Permit of Authorization to Construct an On-Site Sewage Facility Permit Valid For One Year From Date Issued

Permit Number: 118870

Design Report
On-Site Sewage Facility
Aerobic Wastewater Treatment System
Utilizing Surface Spray Application

RE: 415 Lets Roll Dr. Summit Estates 1 Lot 208

Oldham Residence 415 Lets Roll Drive Fischer, TX 78623

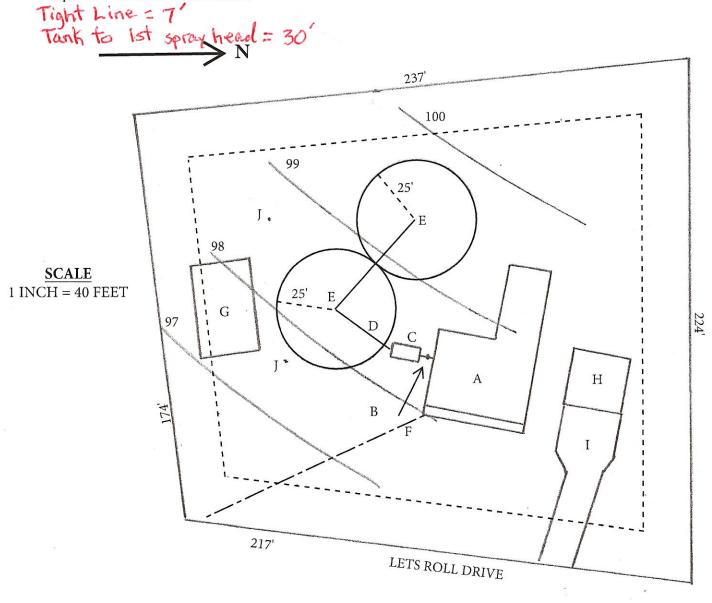
- a. Planning materials state NuWater 800
- 3. Site Plan:

Show the location of the 1-bedroom detached living.

. Show the length of distribution line.

Oldham Residence 415 Lets Roll Drive Fischer, TX 78623

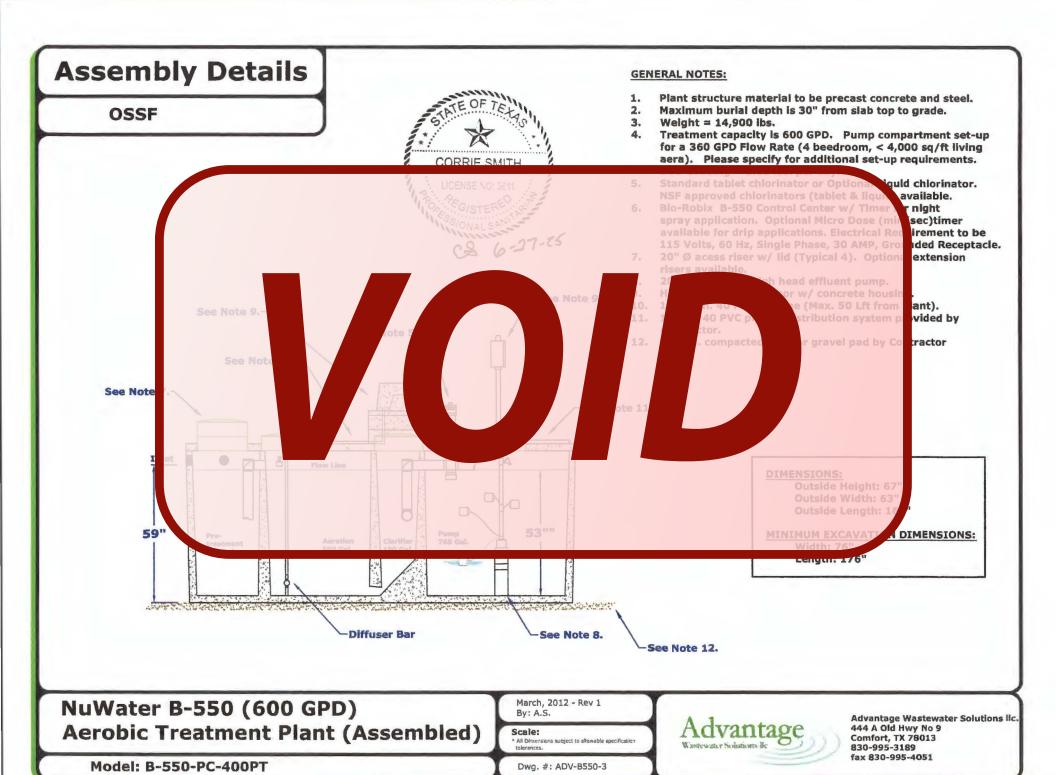
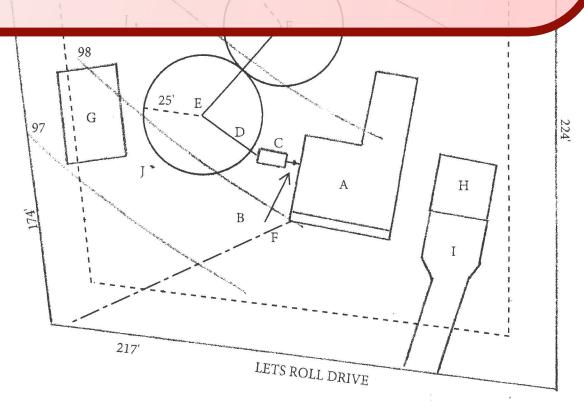
Show the length of the tight line.

Show the link of the distribution lines.
